Evaluation of proposed move for Water Right Nos 1958 & 8600

Proposed: Move water right nos. 1958 and 8600 to a new well location 440 ft to the southwest.

WELL TEST ANALYSIS

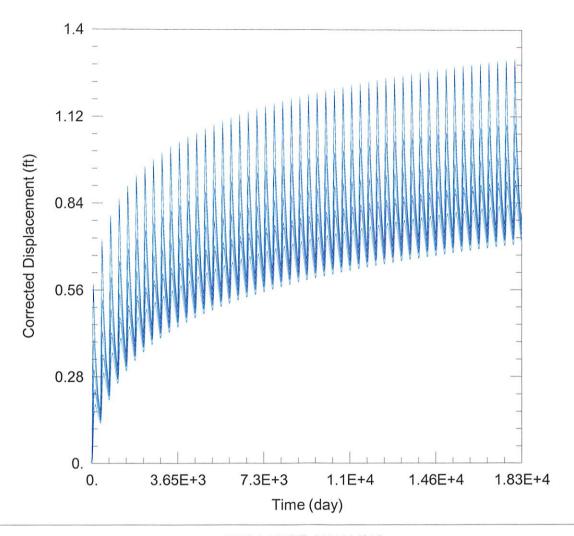
The saturated thickness at the proposed well location is estimated to be 277 ft, based upon the GMD3 model. For saturated thickness greater than 200 ft, the drawdown allowance is 4.0 ft.

50 year Theis Analysis: The following values were used to run the analysis:

S = 0.1475, T = 7344 ft²/day, $tp_{current} = 61$ days (based on average use and reported rate), $Q_{current} = 500$ gpm (reported in 2018), $tp_{proposed} = 93$ days, $Q_{proposed} = 1560$ gpm

Net drawdown exceeds the drawdown allowance of 4.0 ft for water right numbers 17207, 34354 & 45620, 16878, and the domestic well in section 2-29-33. Critical well analysis is necessary on those wells.

If the proposed well is operated at its full authorized rate and quantity, it may have a noticeable effect on some neighboring wells. However, the GMD3 model shows a large amount of remaining saturated thickness in the area, and data indicates that while the aquifer is projected to decline substantially, there will likely be enough remaining saturated thickness for neighboring wells to remain productive for the next 25 years. GMD3 staff recommends approval of the application.
